Addendum No. 1

Reference: Elevator Modernization-Provo Regional Center
Division of Facilities Construction and Management
DFCM Project No. 15038310

Subject: **Addendum No. 1**

THIRD LEVEL FIRE ALARM PLAN
1/8" = 1'-0"

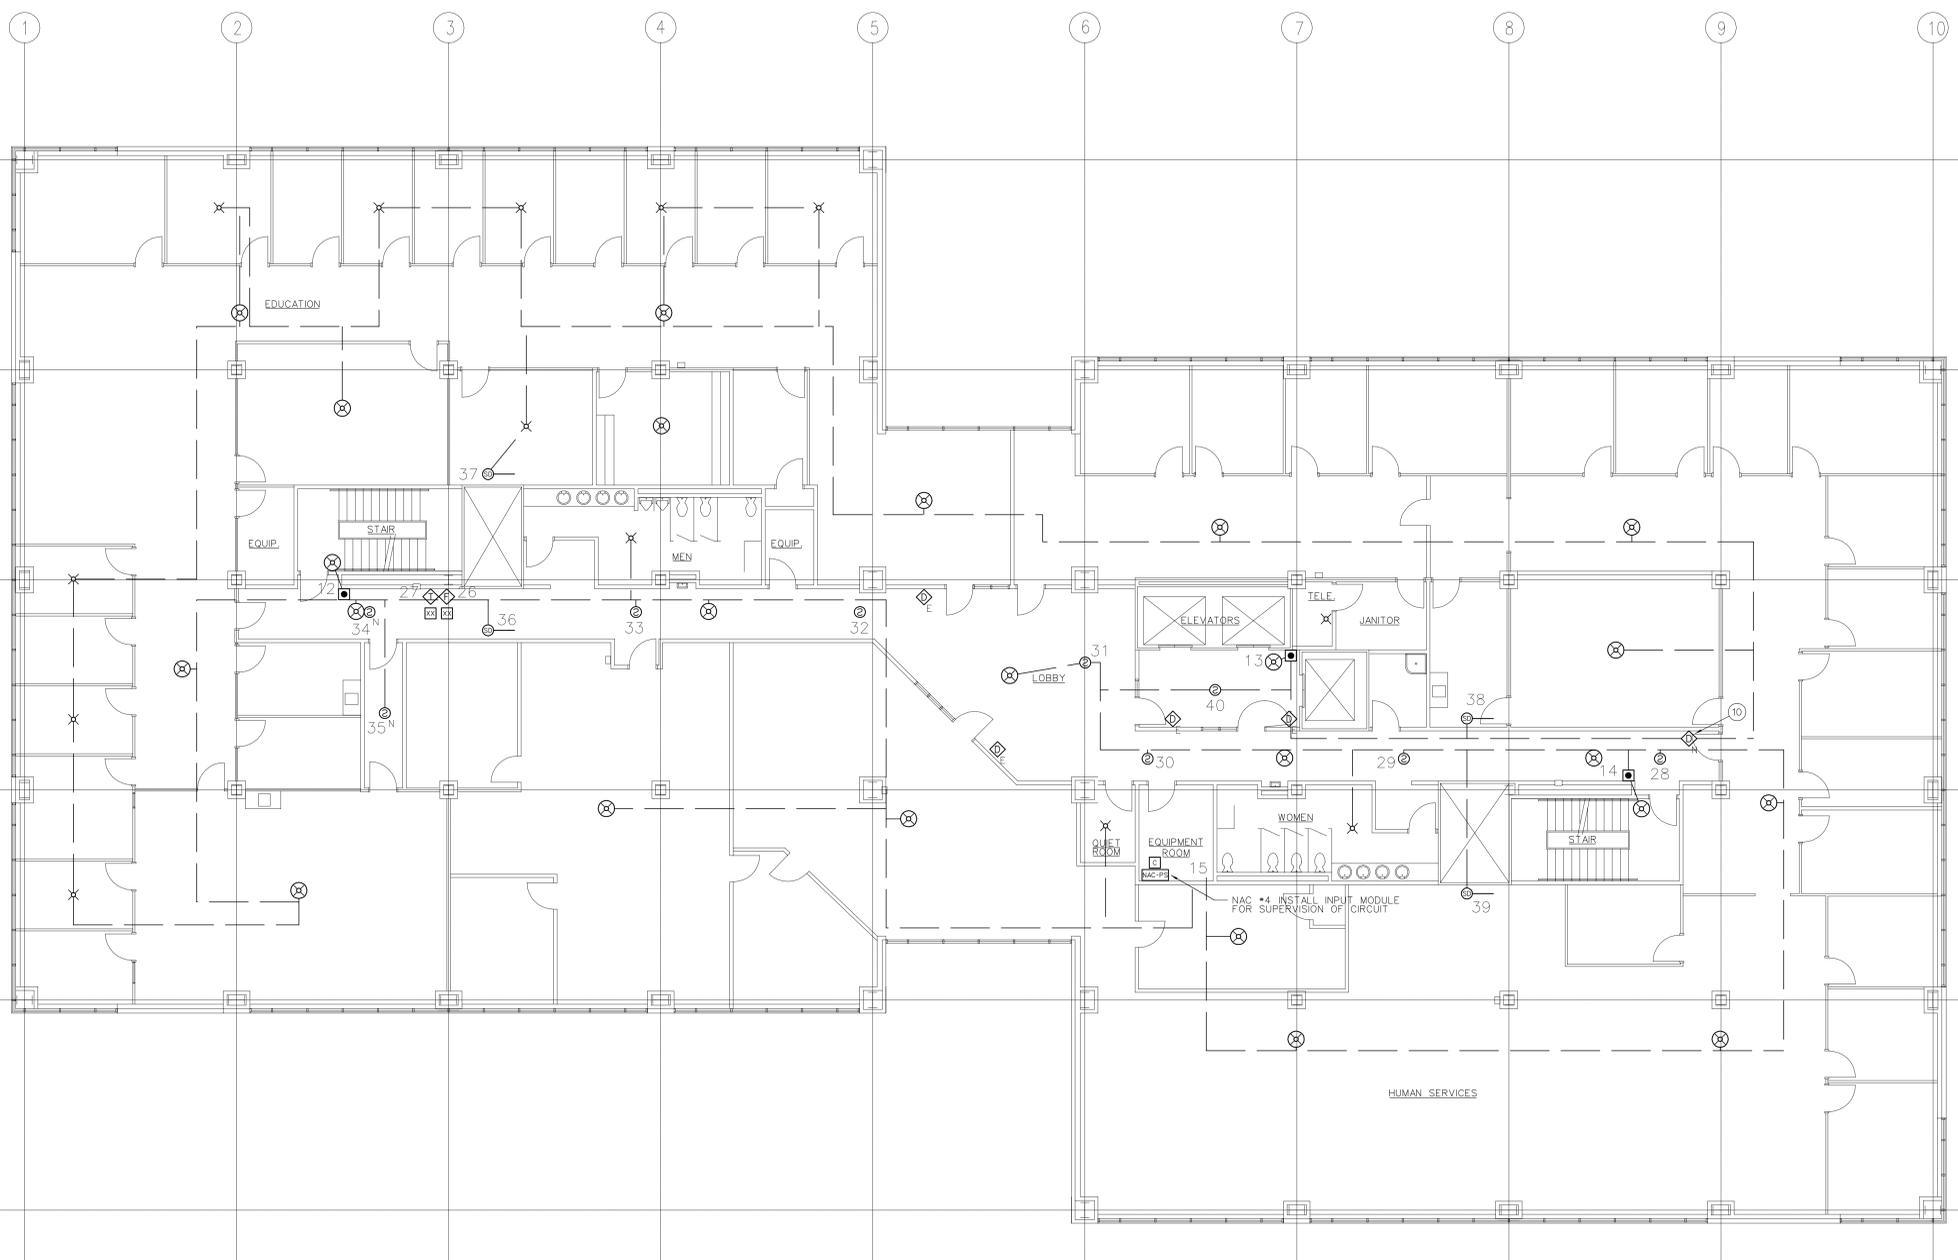
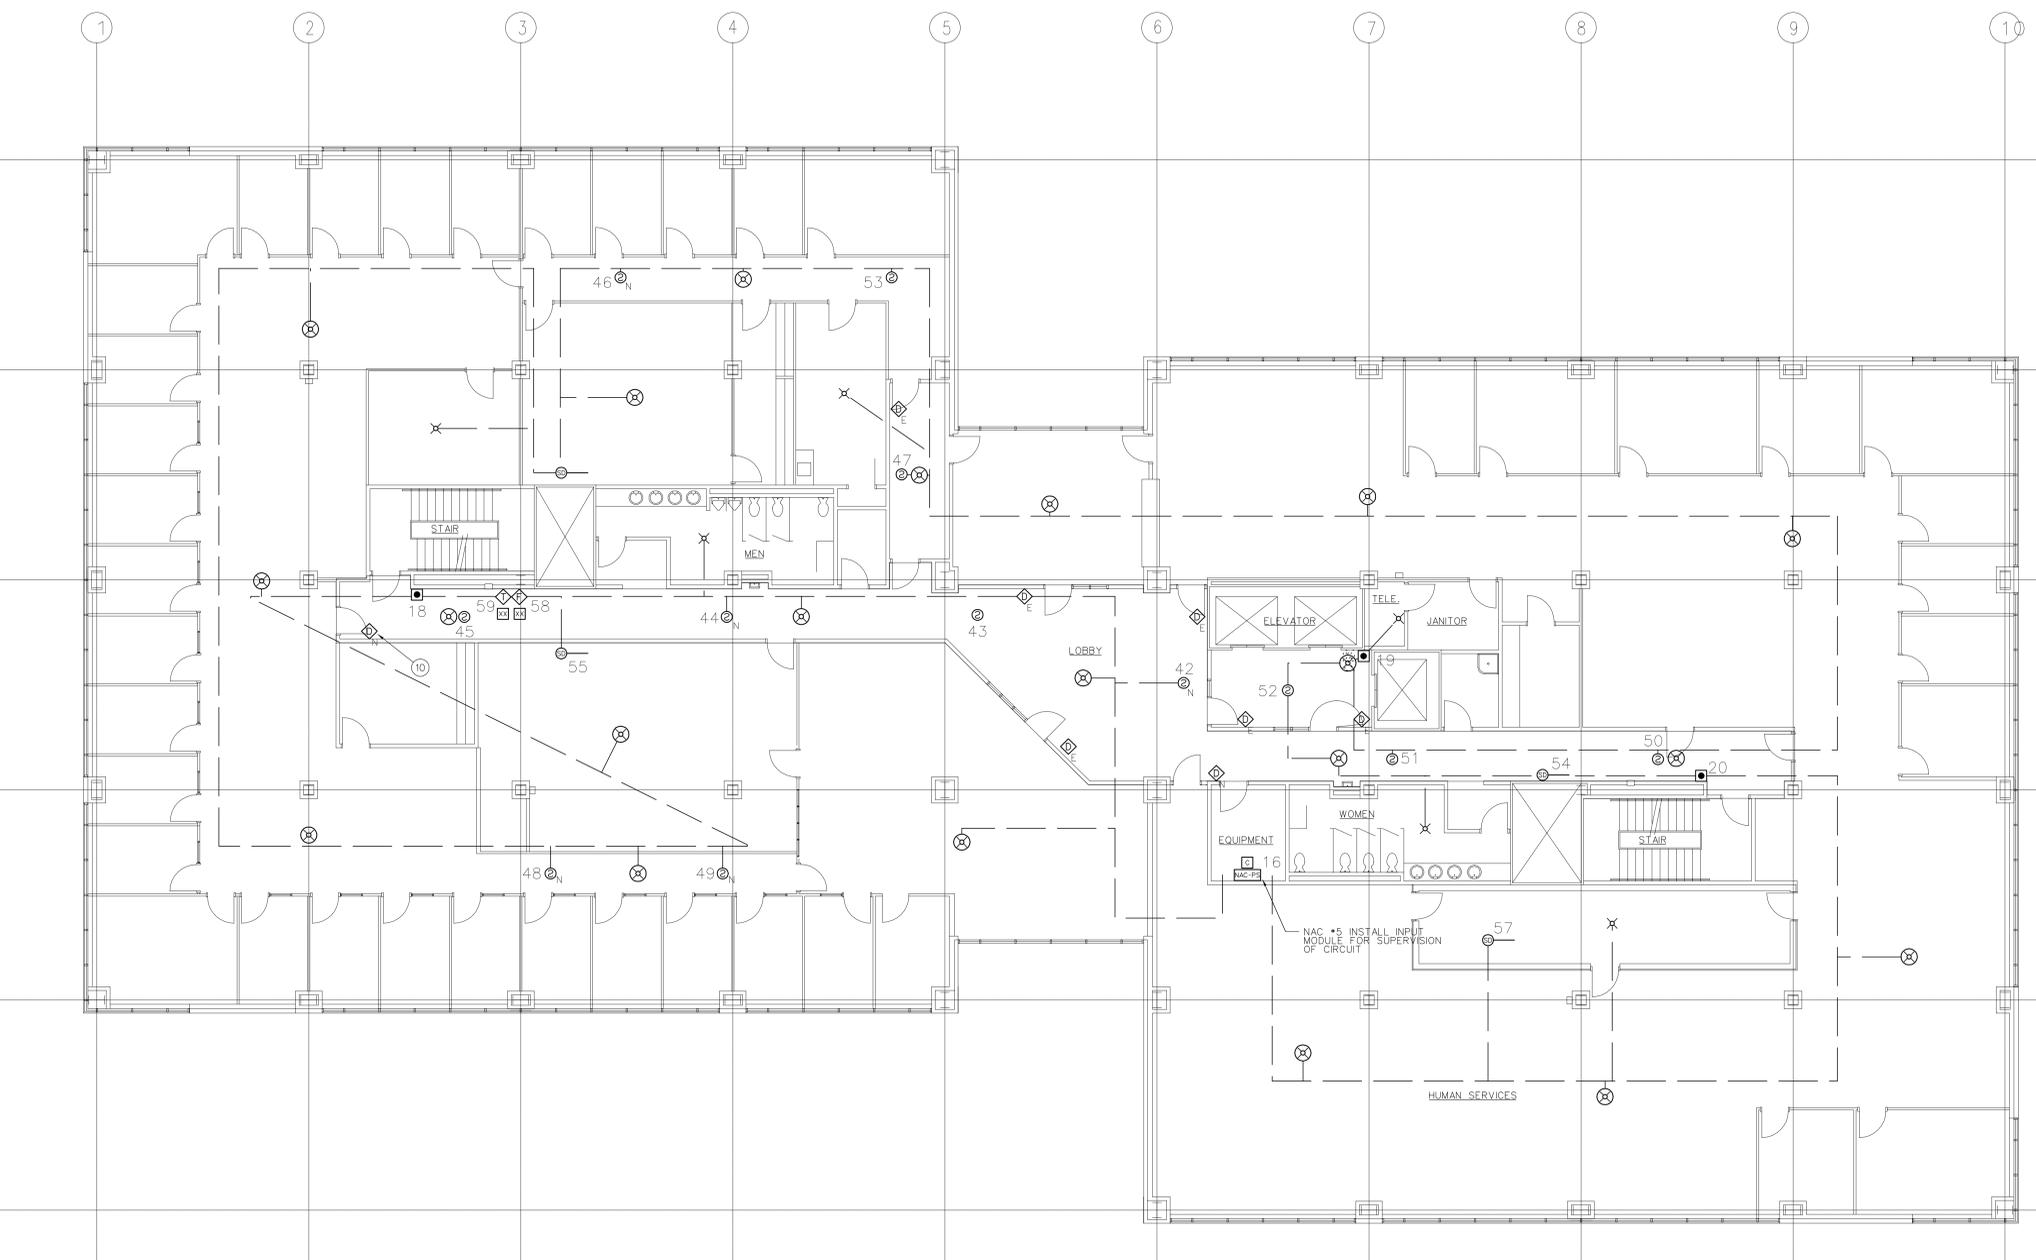
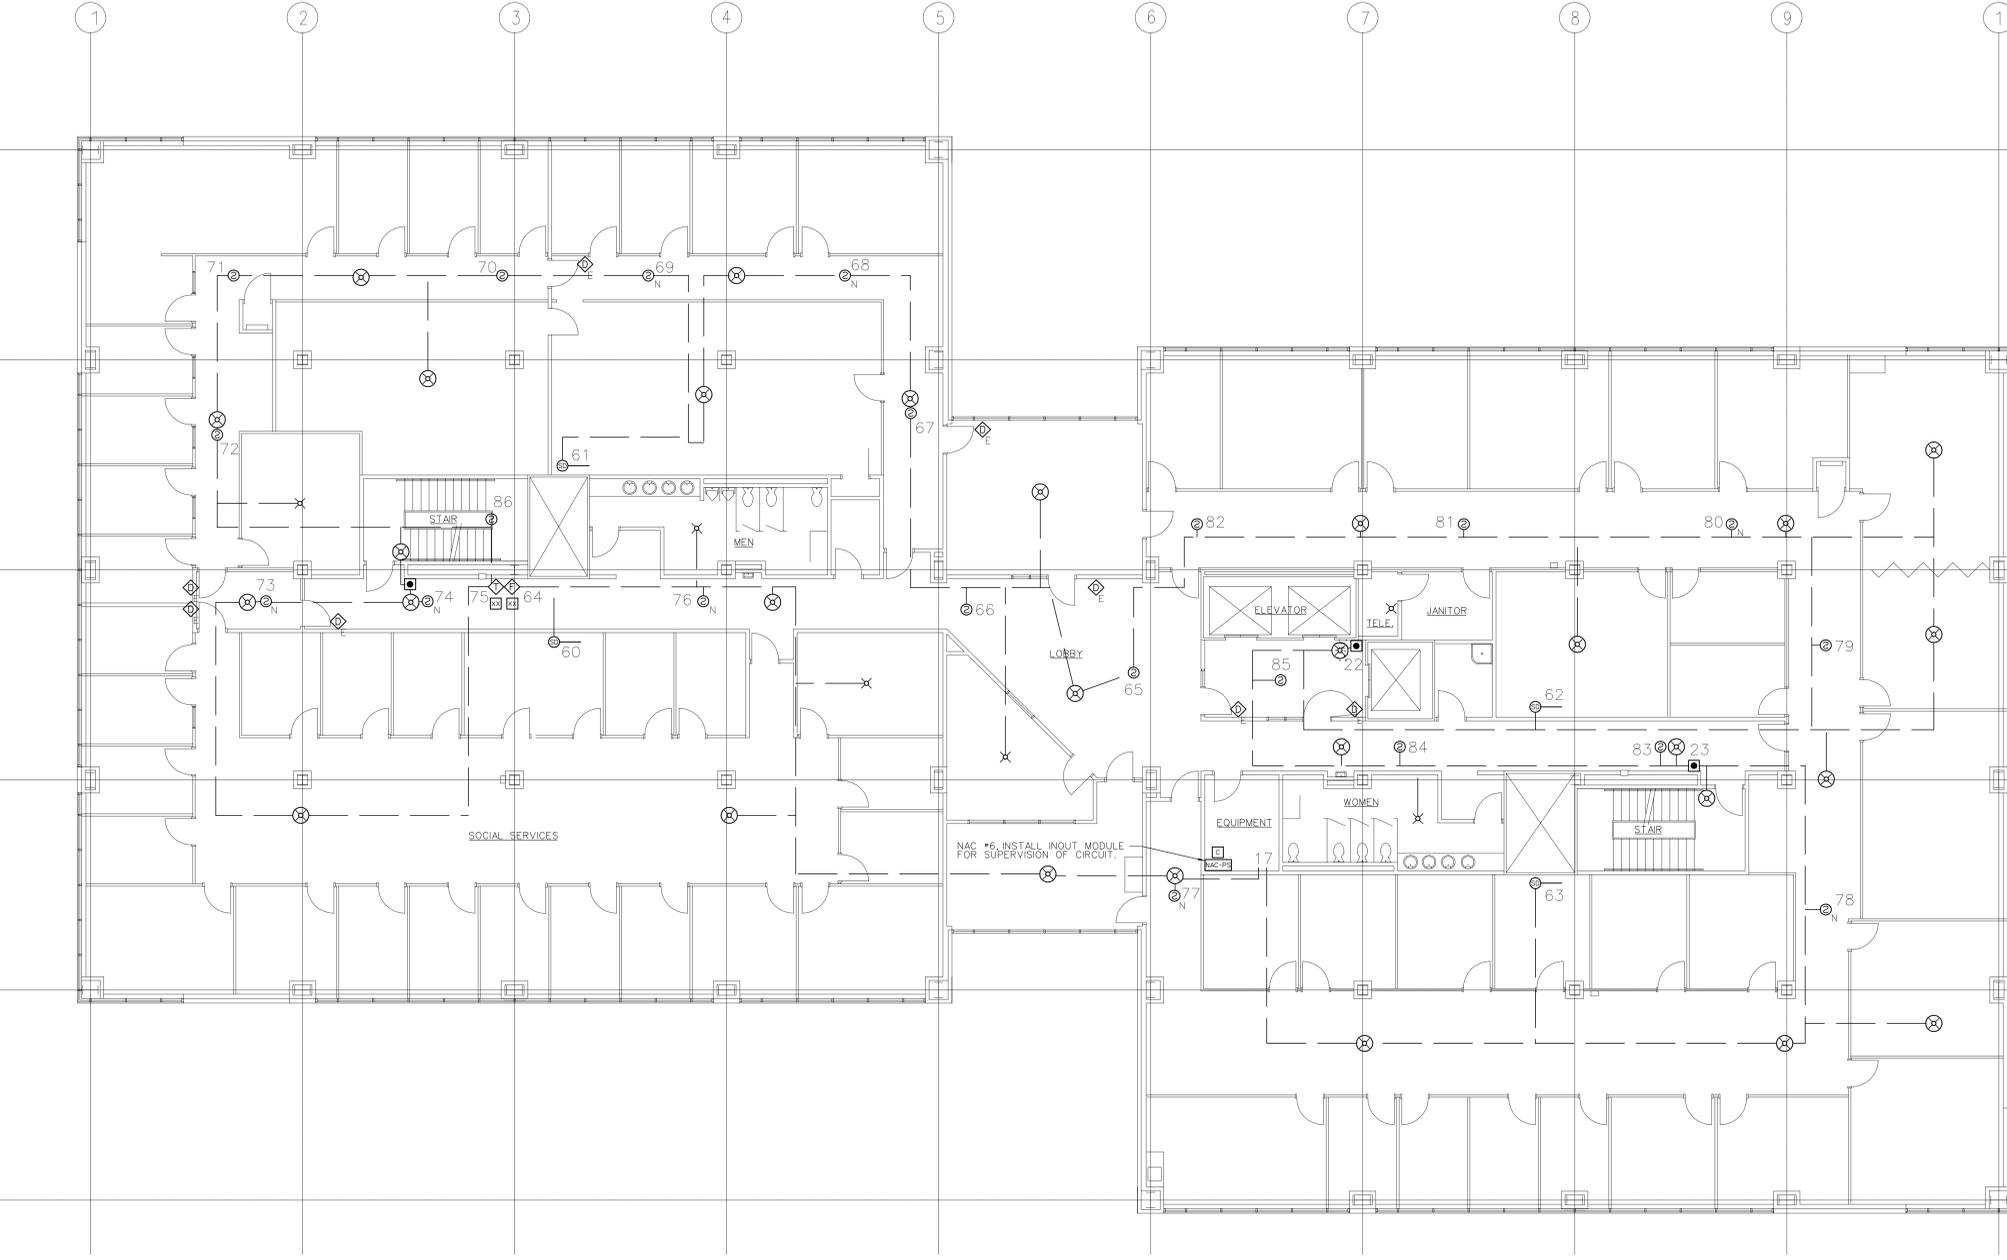
8. Is a building layout drawing available for bidders to review and plan accordingly?

Yes, attached to the addendum are the building's Fire Alarm System drawings per floor and also you can visit the building's haz-mat survey pages 57 through 63 entitled Floor Plans.
